Follows Conditional Case No.: 02-06-2430R
IN REPLY REFER TO:
Case Number: **04-06-039P**
Community Name: City of Albuquerque,
Bernalillo County, New Mexico
Community Number: 350002
Effective Date of
this Revision: APR 1 6 2004

LETTER OF MAP REVISION DETERMINATION DOCUMENT

Re: LOMR Case # 04-06-039P
Construction Plans for the La Cueva Arroyo, I-25 East to Eagle Rock Avenue and the El Camino Arroyo Diversion Storm Drain

Identifier:	Construction plans for the La Cueva Arroyo I-25 East to Eagle Rock Ave. and the El Camino Arroyo Diversion Storm Drain
Flooding Source:	The La Cueva Arroyo and the El Camino Arroyo
FIRM Panels Affected:	Bernalillo County, New Mexico and Incorporated Areas FIRM, number 35001C, panles 0129 E, 0133 E, and 0141 E, all dated April 2, 2002

CITY PROJECT NO. 677181
ZONE MAP NO. C-19-Z
SHEET BL3-3

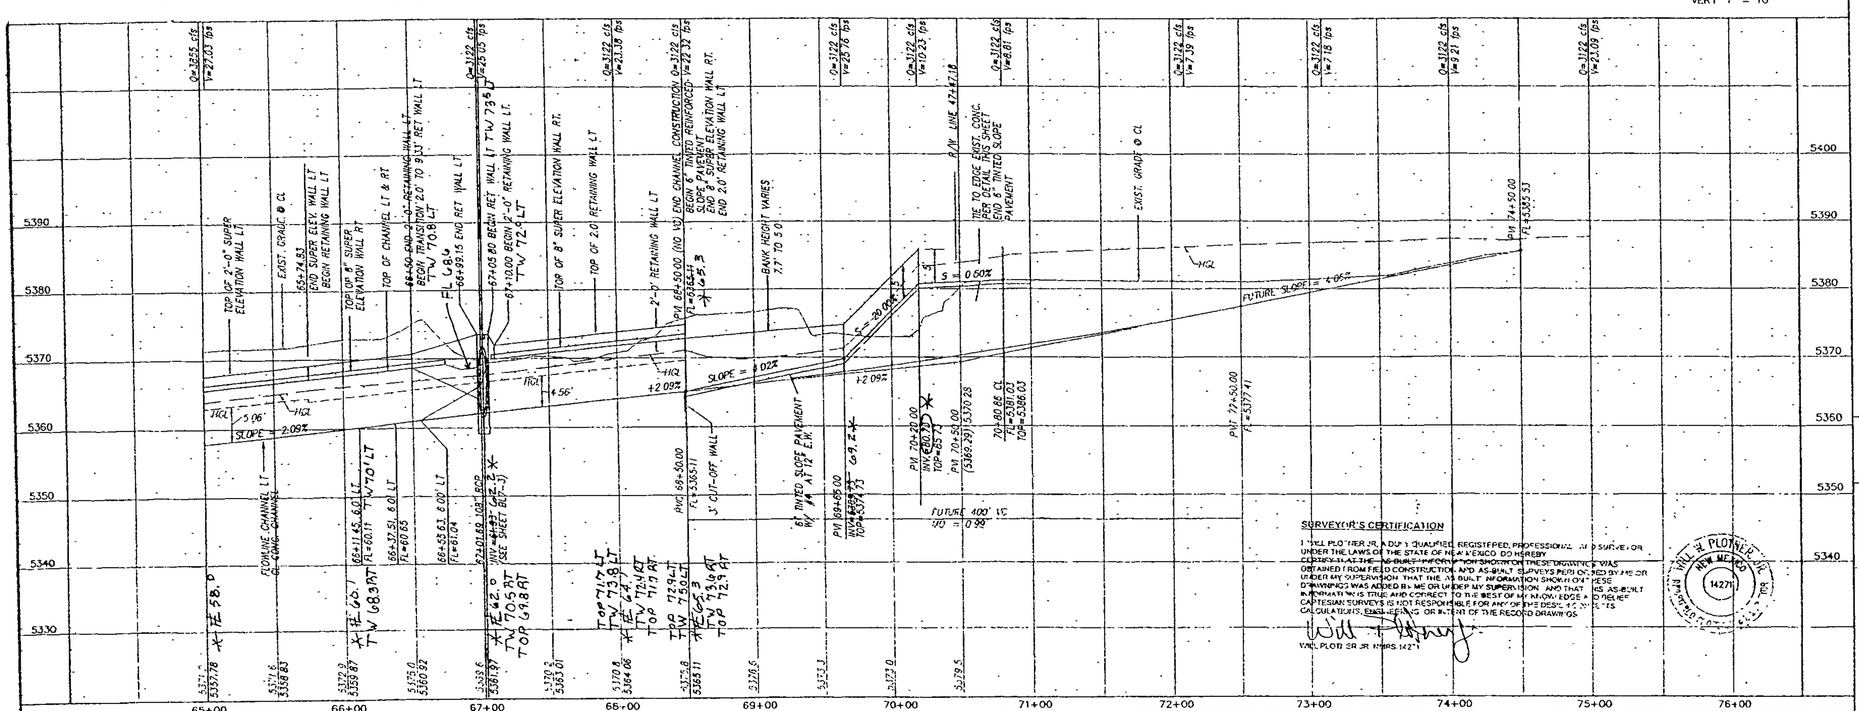
Revised Station 68+50 to 70+92 For Additional Information See Sheet BL3-3A

A00129WP\ CHANNEL\BL7-2.1\05-06-02\MJR GJK RDO

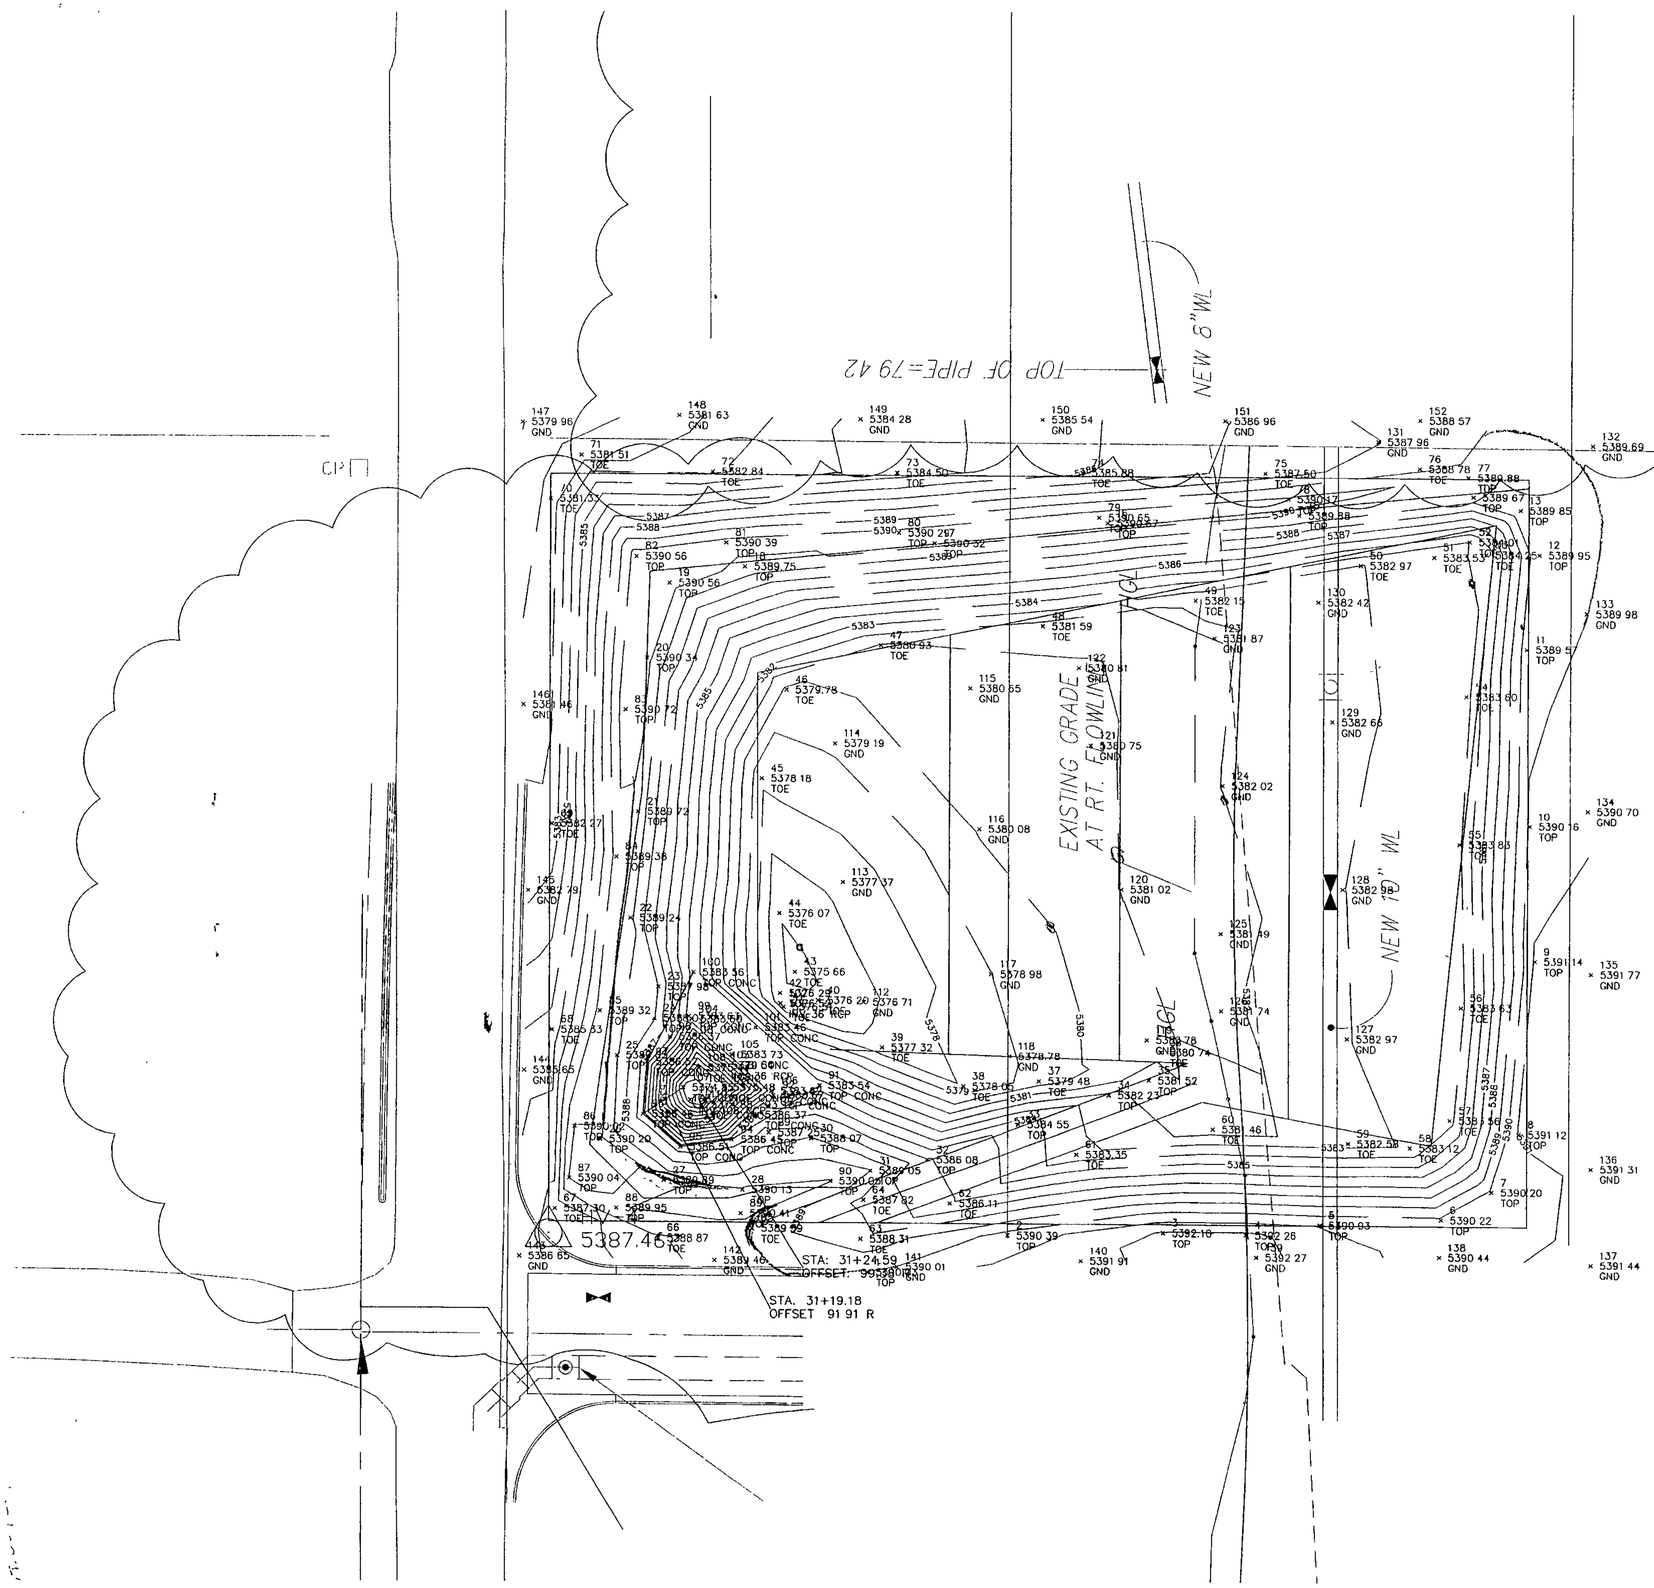
The outfall control structure on the sediment pond at the headworks for the El Camino Diversion was changed (See sheet BL7-2.1 of the construction plans). No new analysis is being offered since improved function seems evident.

MAP NUMBER
35001C0129 D

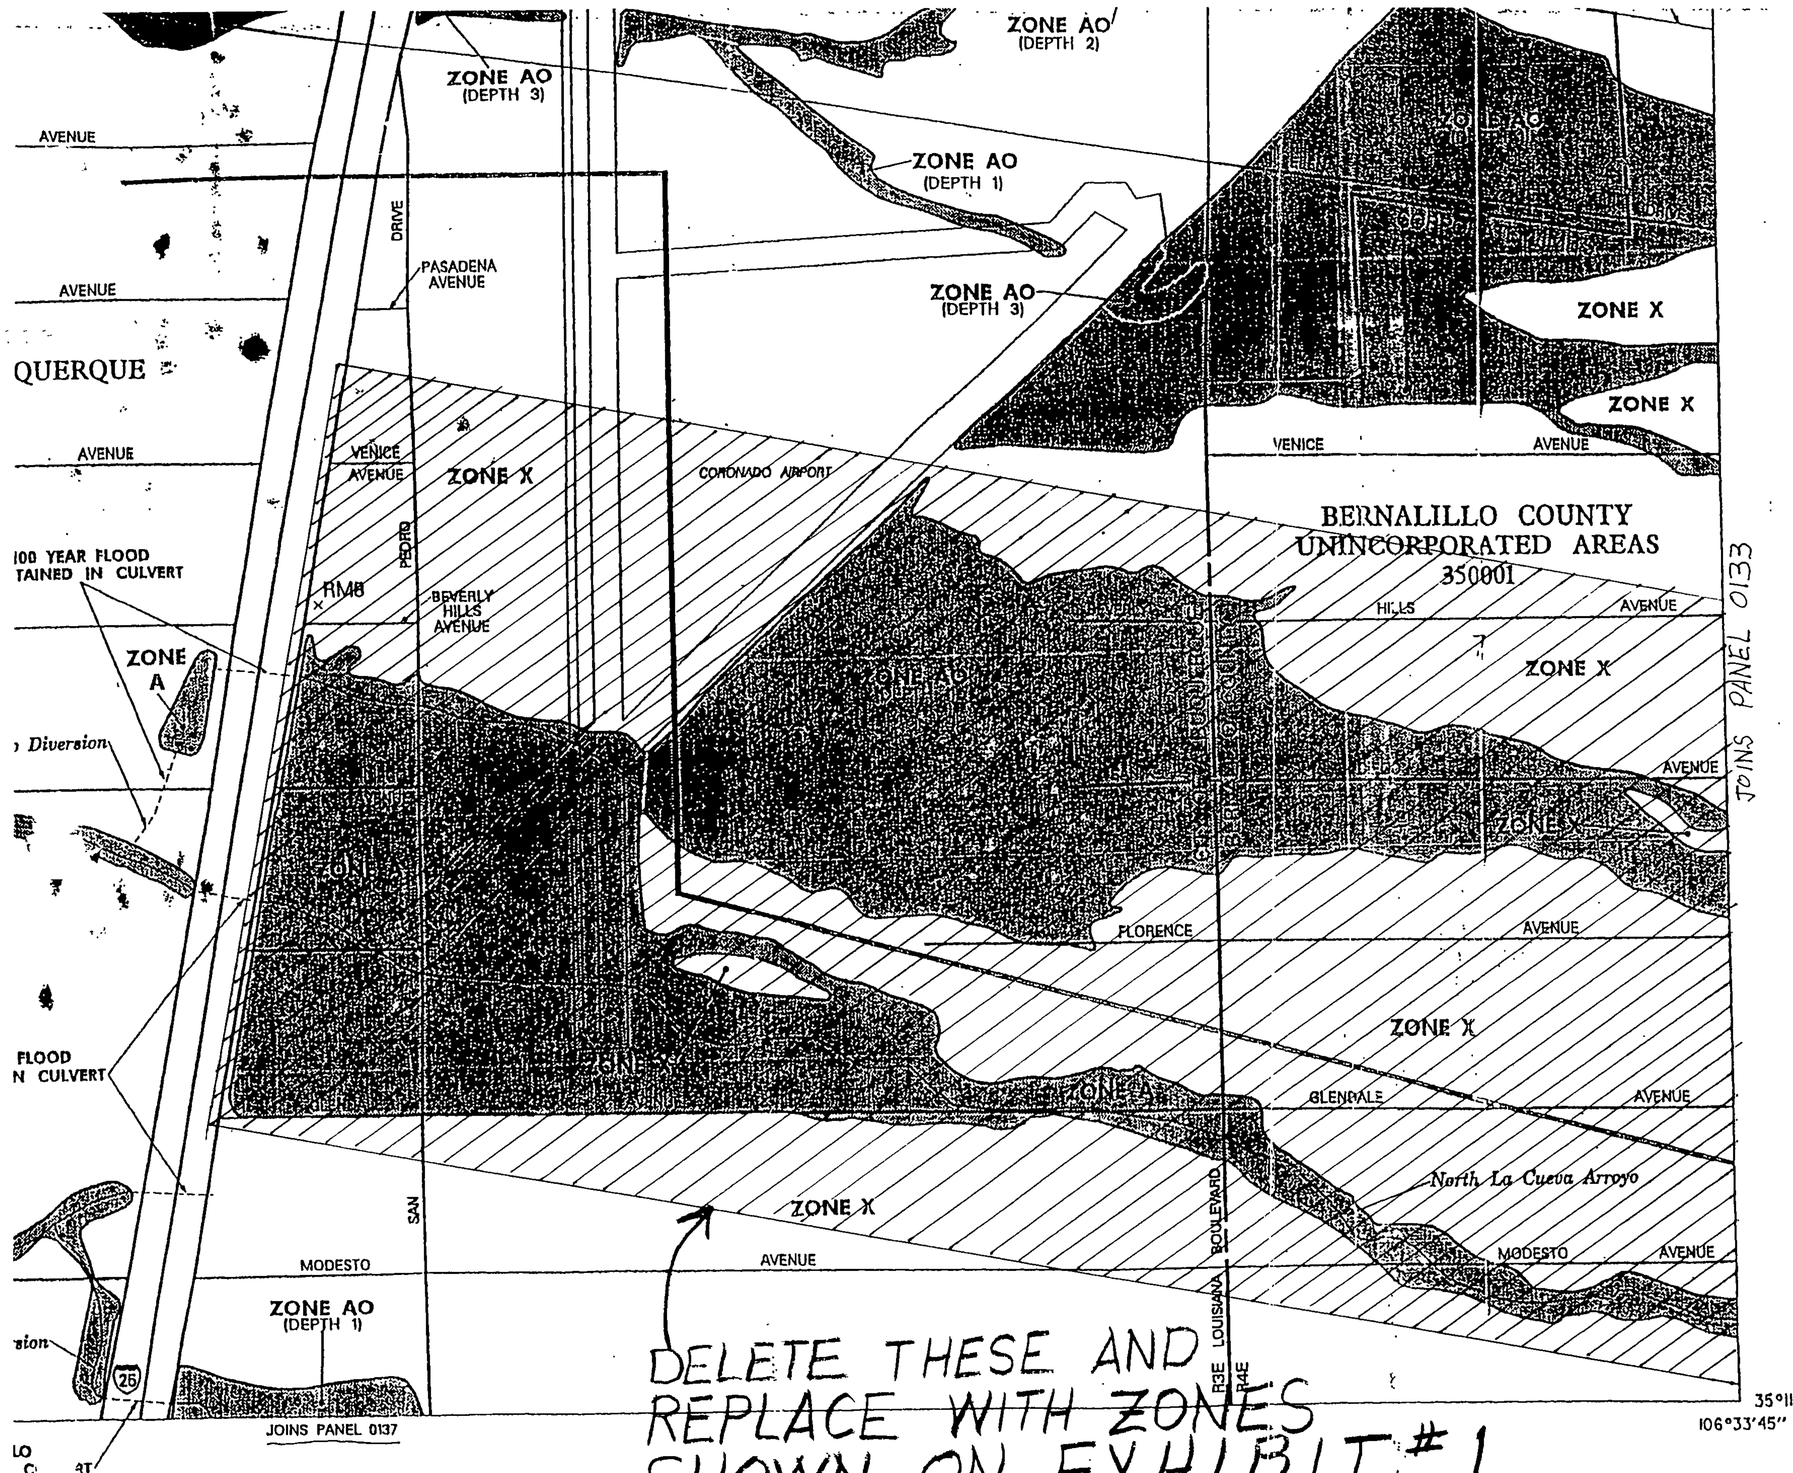
DELETE THESE AND
REPLACE WITH ZONES
SHOWN ON EXHIBIT #1
